Product Safety Recall

N202322234 Seat Belt May Not Be Properly Attached

Revision: 01

Revision Description: This bulletin has been revised to include a copy of the customer notification letter. Please discard all copies of bulletin N202322234.

5699168

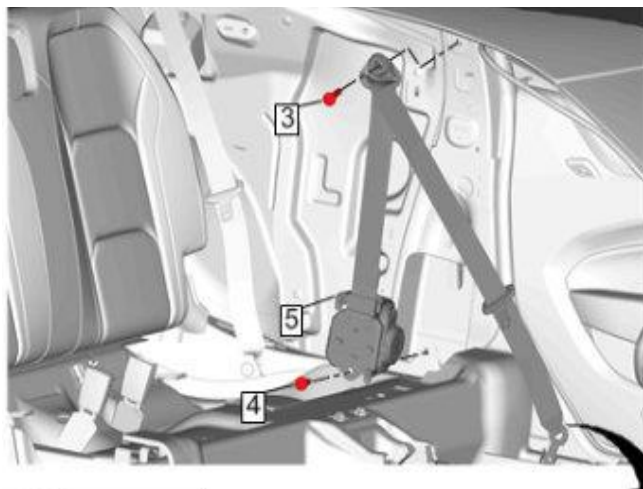
2. Remove the front seat belt retractor mounting bolt (4). Discard the bolt.
3. Install the new seat belt retractor mounting bolt (4). Refer to the note above for installation details. Tighten the new service bolt to 45 N.m (33 lb. ft).
4. Reinstall the left quarter lower rear trim panel. Refer to *Quarter Lower Rear Trim Panel Replacement* in SI. If the rear seat belt anchor mounting bolt requires replacement, perform that procedure before reinstalling the trim panel.
5. Repeat steps 1-4 on the right-side seat belt retractor mounting location.

4140498

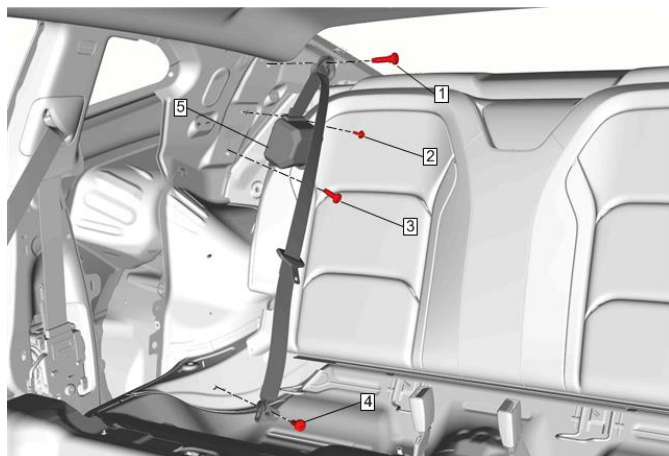
1. Remove and discard the seat belt anchor bolt (4).
2. Install the new seat belt anchor mounting bolt (4). Refer to the note above for installation details. Tighten the new service bolt to 45 N.m (33 lb. ft).
3. Reinstall the quarter lower rear trim panel. Refer to *Quarter Lower Rear Trim Panel Replacement* in SI.

NOTE: Passenger Side Shown, Drive Side Similar

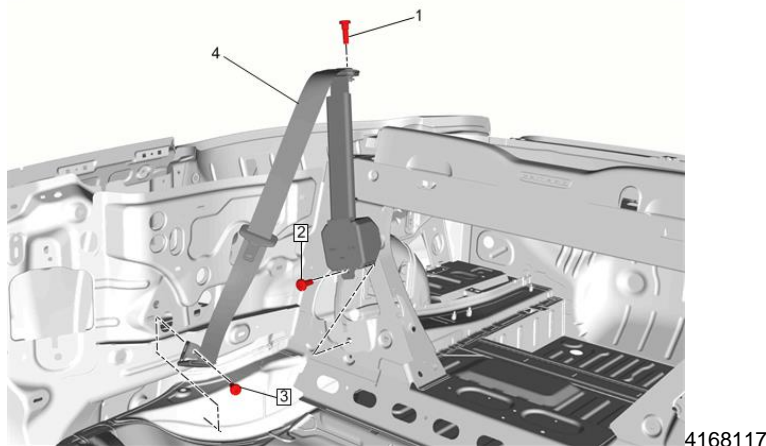
2. Remove and discard the seat belt anchor bolt (3).
3. Install the new seat belt anchor mounting bolt (3). Refer to the note above for installation details. Tighten the new service bolt to 45 N.m (33 lb. ft).
4. Reinstall the quarter lower rear trim panel. Refer to *Lower Rear Trim Panel Replacement* in SI.
